Mandatory bulletin

No.: G304CZ - 05 a)
G304CZ17 - 05 a)

Type : Type Certificate No.: 98-03
Model: Glasflügel 304 CZ, Glasflügel 304 CZ-17, Glasflügel 304 C
Serial No.: 1 to 60-17

Subject : Airbrake handle check.

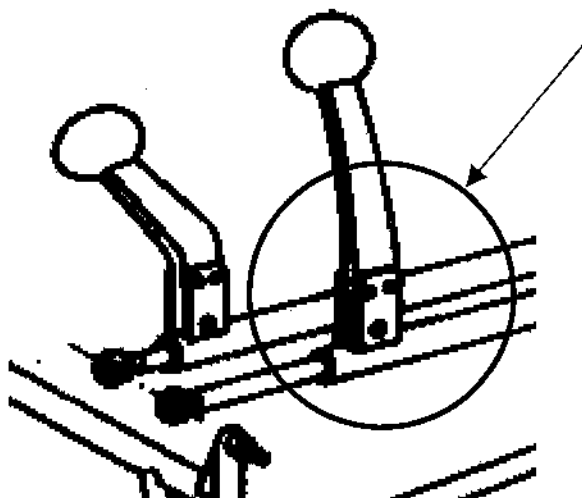
Action: Check the joint of the airbrake handle with the rod.

- The joint must be made of three countersink head rivets.
- The joint may not have a free play under operating loads.
- Visually check the material of the rivets.
- Original steel rivets should not be replaced.
- If the duralumin rivets are used then replace them by steel rivets 4x12 DIN 661.
- Secure the joint with the epoxy Loctite 3422
- curing time 2 hours/ 22°C.
